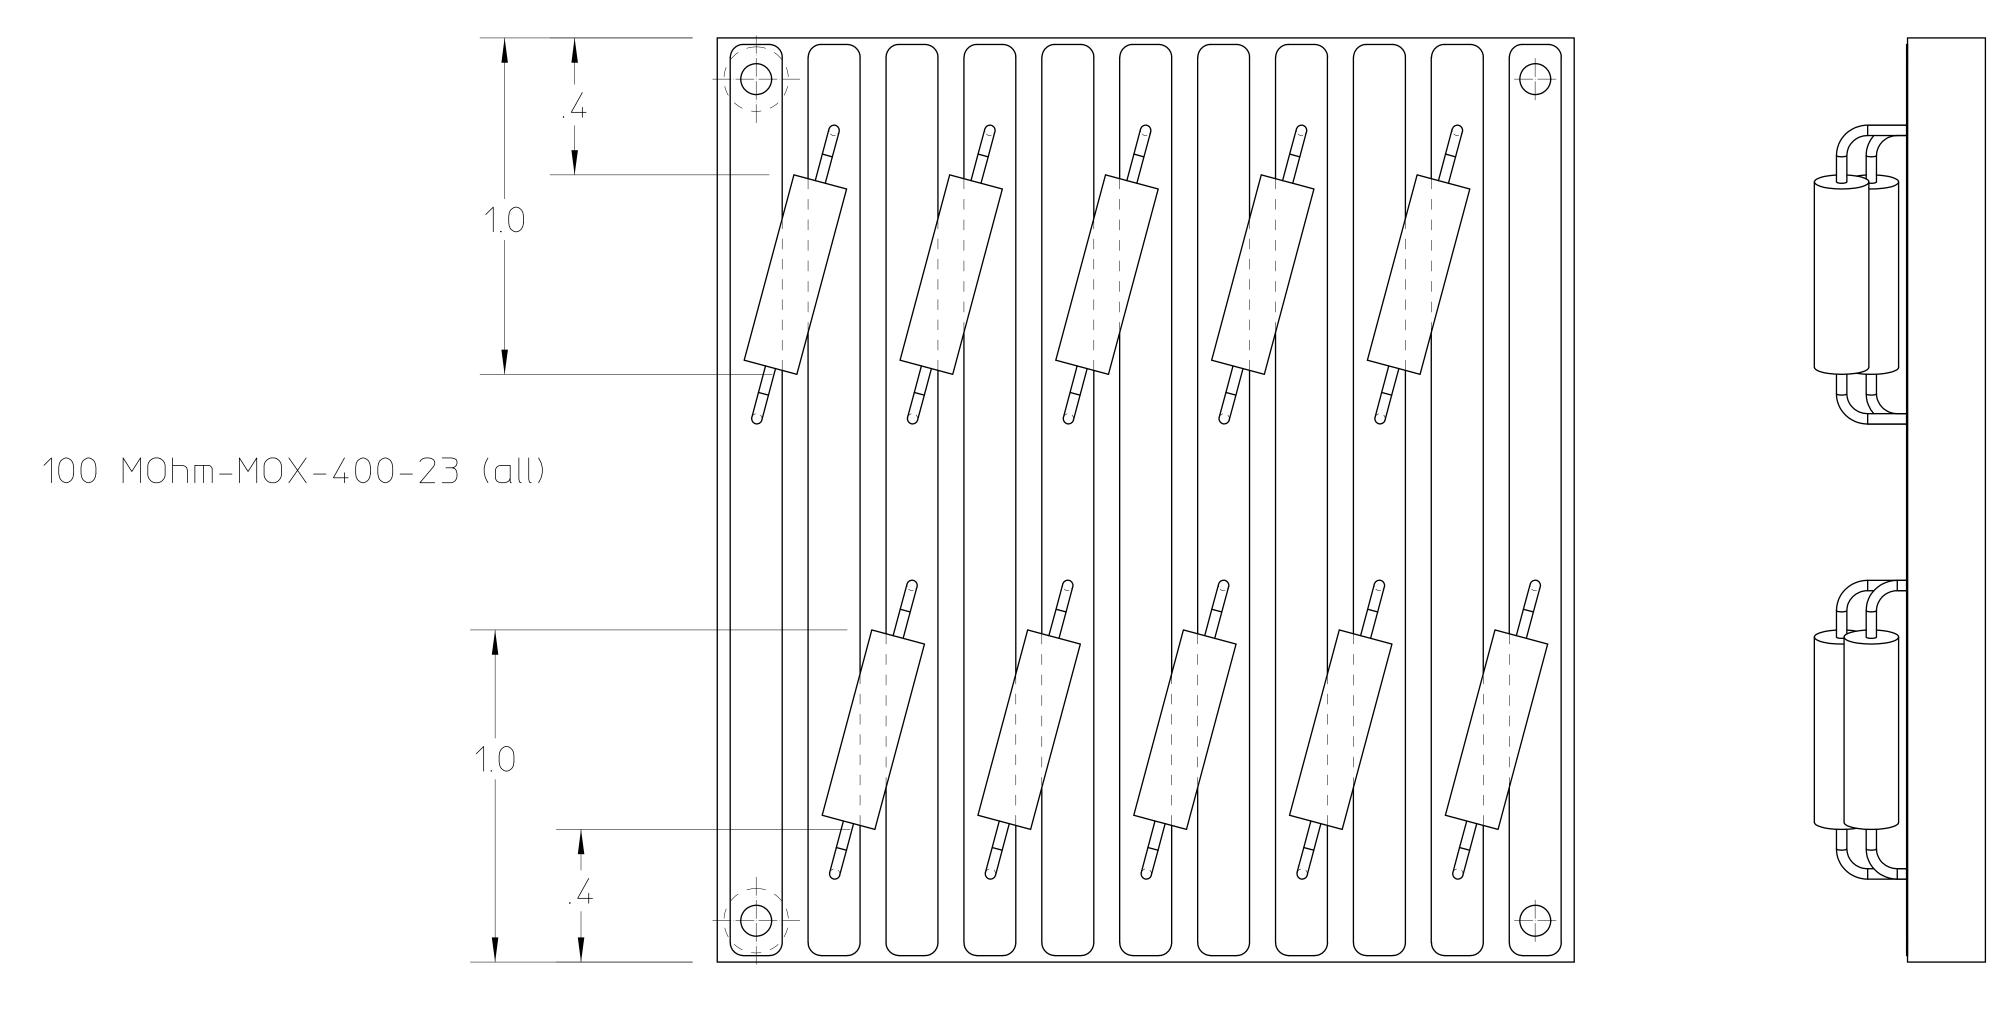
LEADS TO HAVE FLAT SECTION ADDED (.1"/.2" LG.) FOR PAD CONTACT BEND LEADS CLOSER TO RESISTOR BODY TO PROVIDE FLAT SECTION
